**FINDINGS AND RECOMMENDATION
OFFICE OF PLANNING AND ZONING
ANNE ARUNDEL COUNTY, MARYLAND**

CASE NUMBER: 2024-0215-V

VARIANCE/GRADING & SEDIMENT CONTROL PLAN

LOTS 22 & 23, BLOCK 36B, SECTION E,
HERALD HARBOR

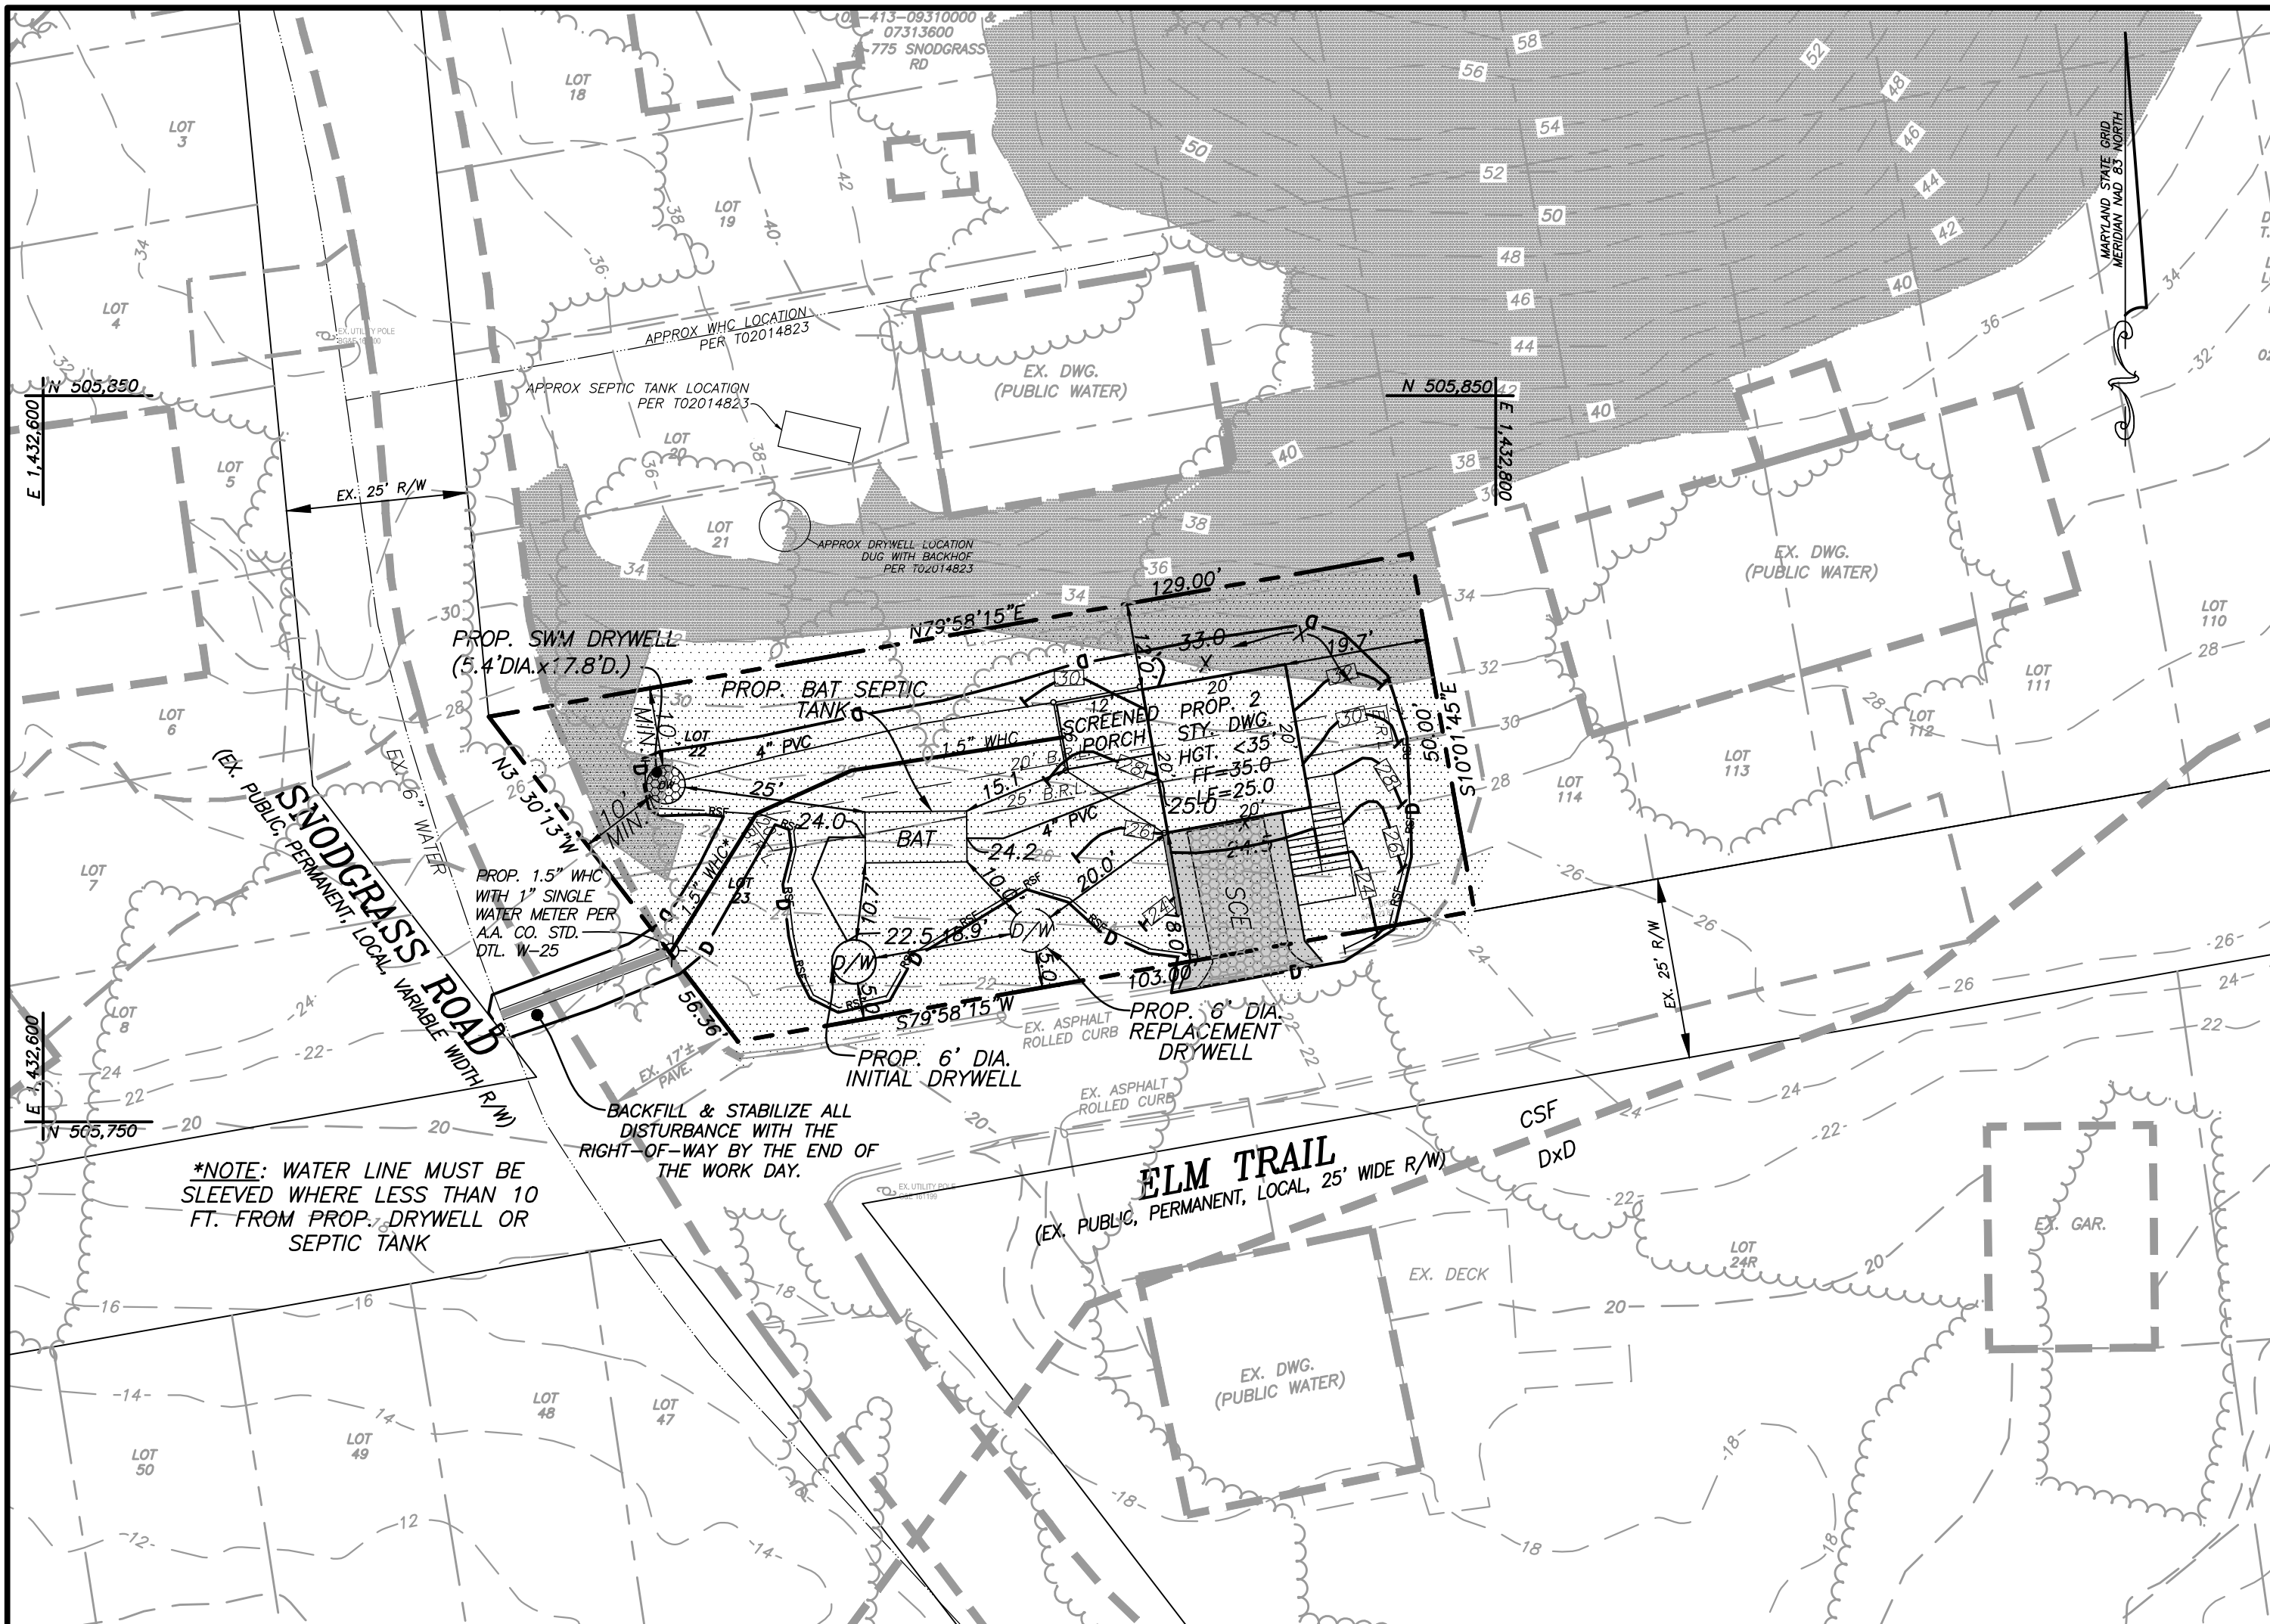
1. On the Revised Site Plan, the legend shows a symbol for existing 15% to 25% slopes and another symbol for existing 25% slopes. However, on the Plan View of the Revised Site Plan, it appears only the symbol for existing 25% slopes is shown; the symbol for existing 15% to 25% slopes is not shown. Show the existing 15% to 25% slopes on the Plan View of the Revised Site Plan and ensure the symbol provided in the legend is the same symbol used for this feature in the Plan View of the Revised Site Plan. If existing 15% to 25% slopes are not to be shown on the Plan View of the Revised Site Plan, then remove this symbol from the legend. See comment #9 of the original Engineering Review comments.

2. On the chart entitled Building Permit Site Data, found on the bottom right-hand corner of the Revised Septic Plan, the Proposed Impervious Cover is listed as 908 sq ft. However, on the table labelled Site Analysis found on the right side of the Revised Site Plan, the Proposed Lot Coverage is listed as 916 sq ft. Please clarify why these values do not match. See comment #14 of the original Engineering Review comments.

4. On the table entitled Critical Area Tabulation, found on the left side of the Revised Site Plan, the Maximum Lot Coverage (within C.A.) is listed as 1,950 sq ft. However, on the first paragraph of the second page of the Revised Critical Area Report Narrative, the "allowable lot coverage per classification...is 1,963 sq ft." As mentioned in comment #27 of the original Engineering Review comments, these two values must match each other. Please revise this accordingly.

3. The Code reference for the zoning setbacks has been updated; however, the requested relief is unaffected.
4. The hatching for lot coverage shown on the County topo map has been thawed.

5. With the reduction in the building footprint the downspouts along the eastern side are unnecessary and have been removed from the plan.
6. The address on the Variance application has been corrected to match the Site Plan.

7. As shown on the Site Plan, asphalt curb exists on both sides of Elm Trail.
8. The linetype for the existing water line has been shown in the Legend.
9. The limits of 15%+ slope are shown on the Variance Site Plan. The Environmental Health Department does not require setbacks to 15%+ slopes; therefore, only the 25%+ slopes are reflected on the Septic Plan.

34. The plan has been revised to label the size of the water connection and existing mains abutting the site.
35. The approved red-stamped septic plan for the new/reduced dwelling has been submitted herewith.

SEPTIC PLAN
LOTS 22 & 23 HERALD HARBOR
TAX MAP 31 BLOCK 23, PARCEL 390
ZONED R5

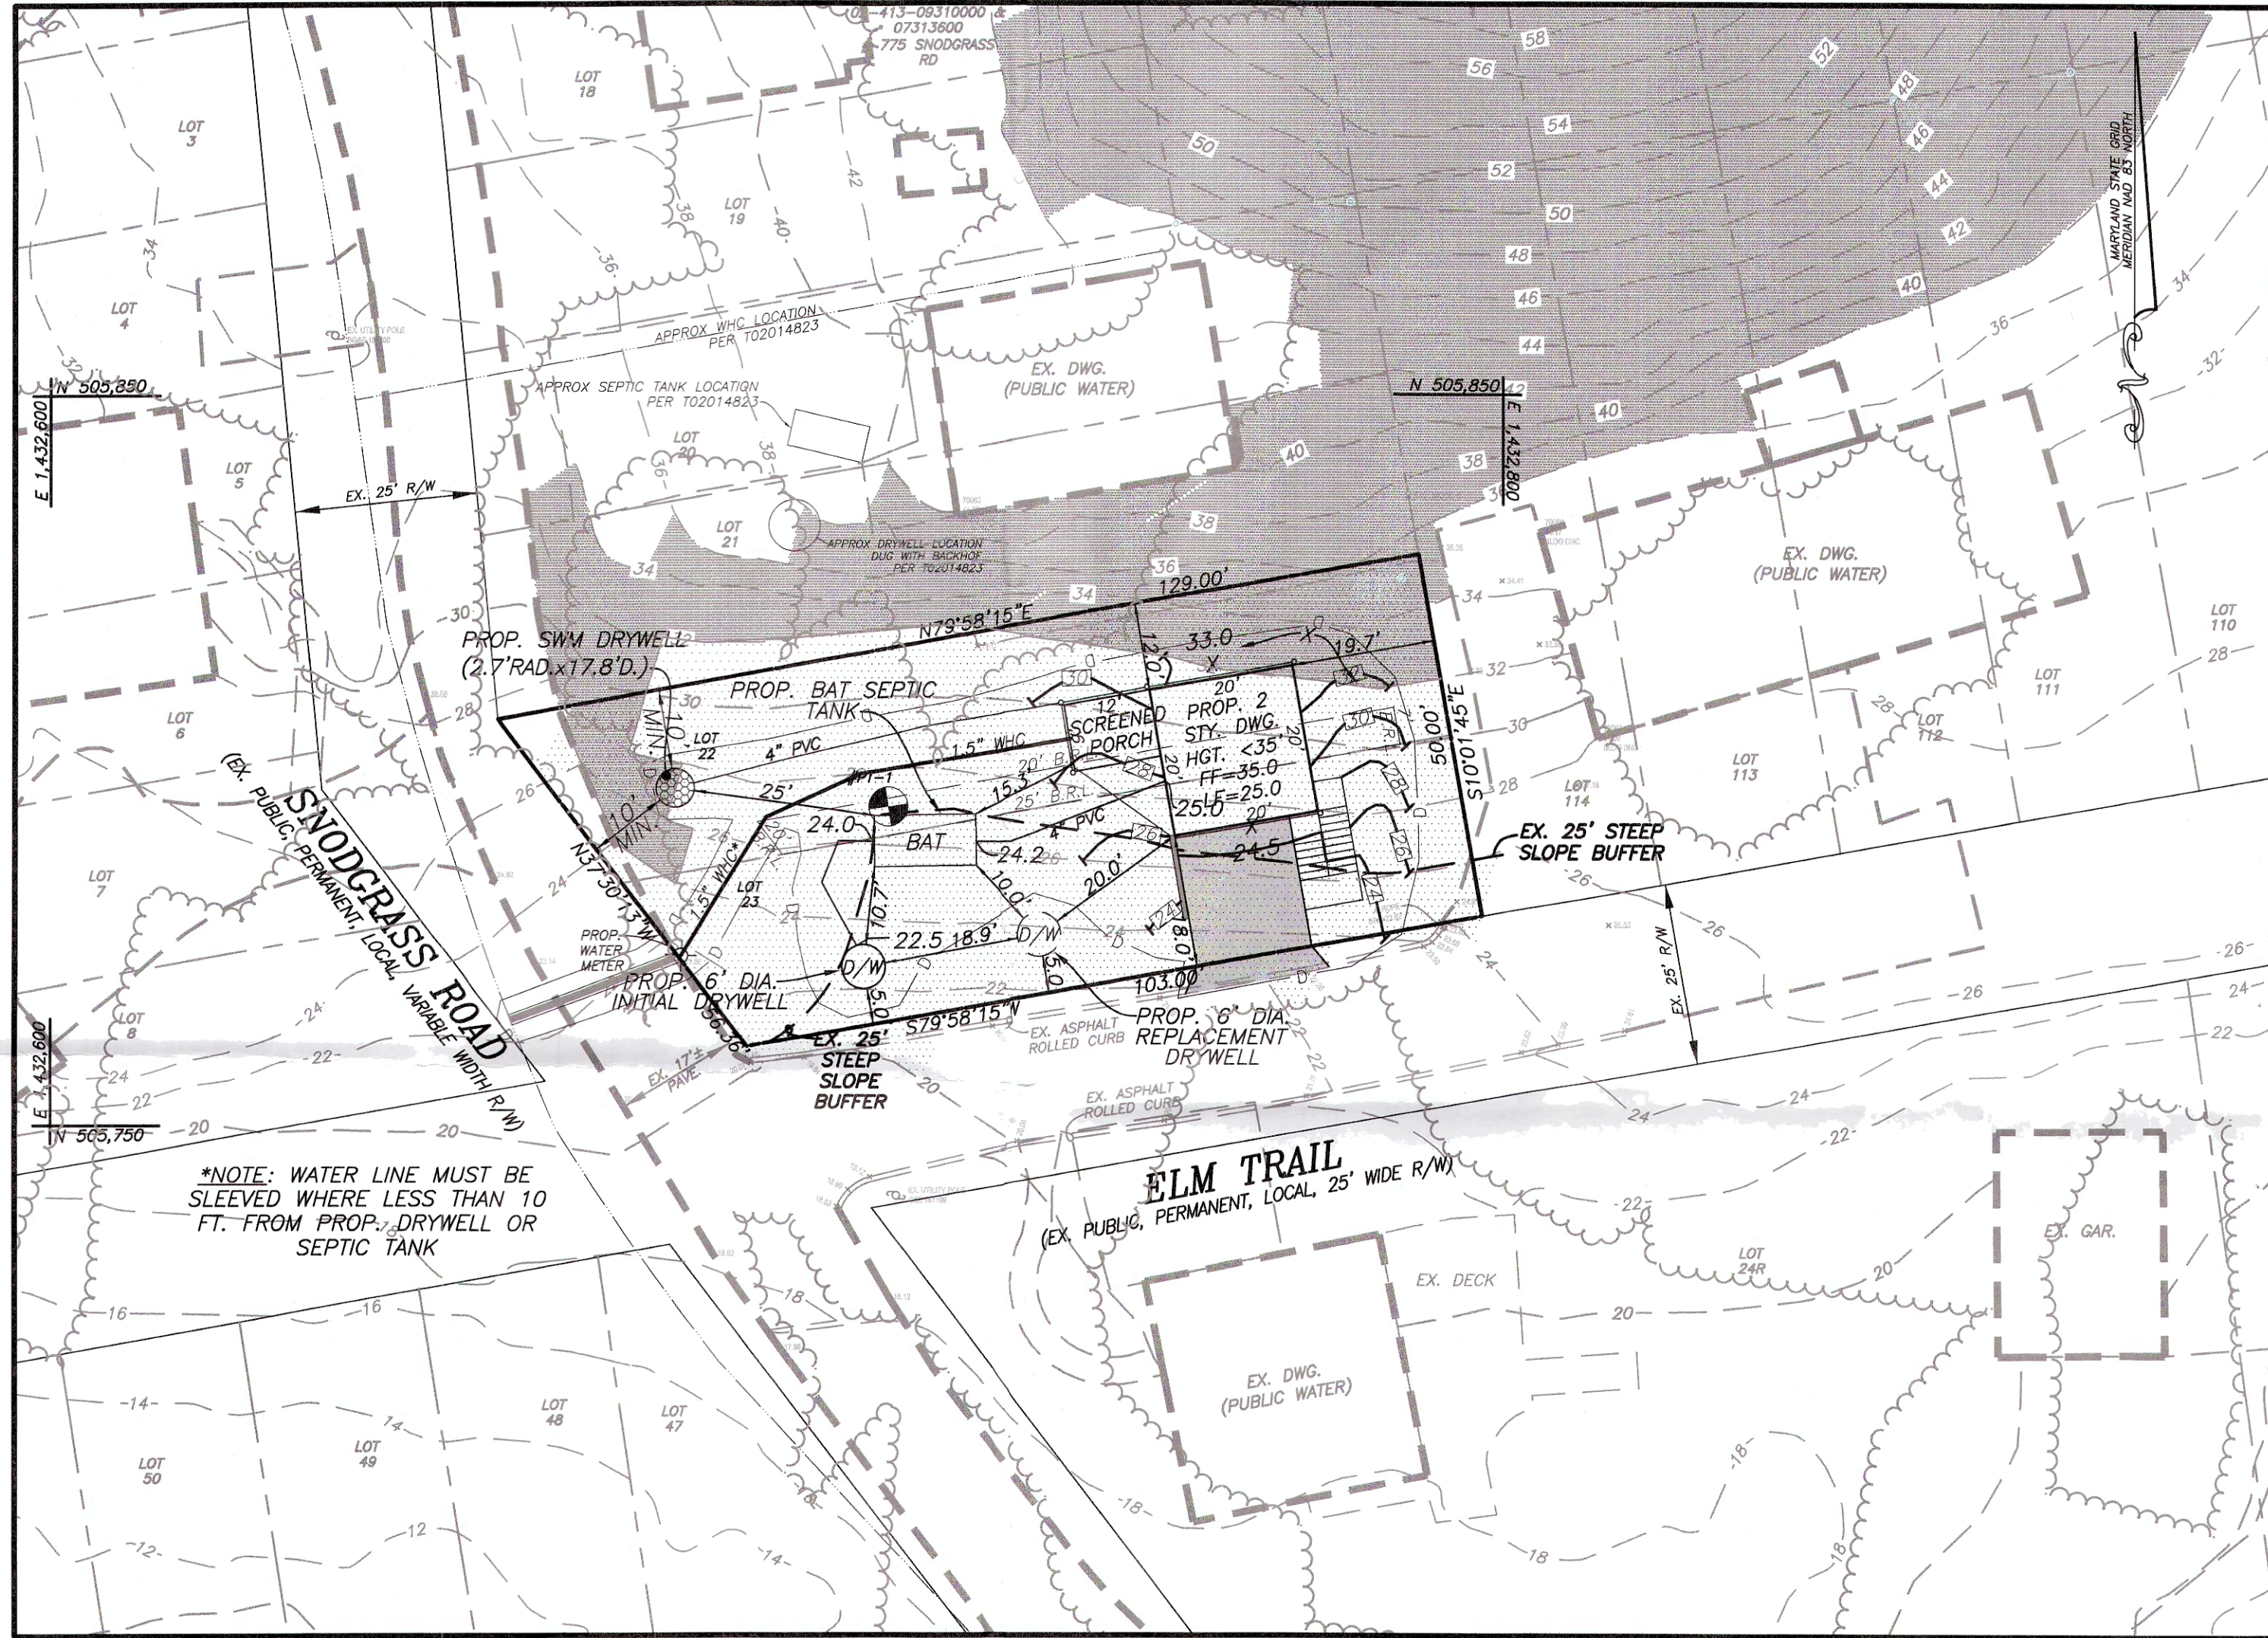
The Health Department has reviewed the above reference request. The site plan submitted with the variance request does not match the approved site plan. The site plans must not match before a decision can be rendered by the Health Department .

The septic plan for the revised house and site improvements was approved on 2/4/25, as shown by the red-stamp septic plan submitted herewith.

13. The year of the SCS specifications has been updated to 2011.
14. The septic plan has been revised to reflect the reduced dwelling size and lot coverage.
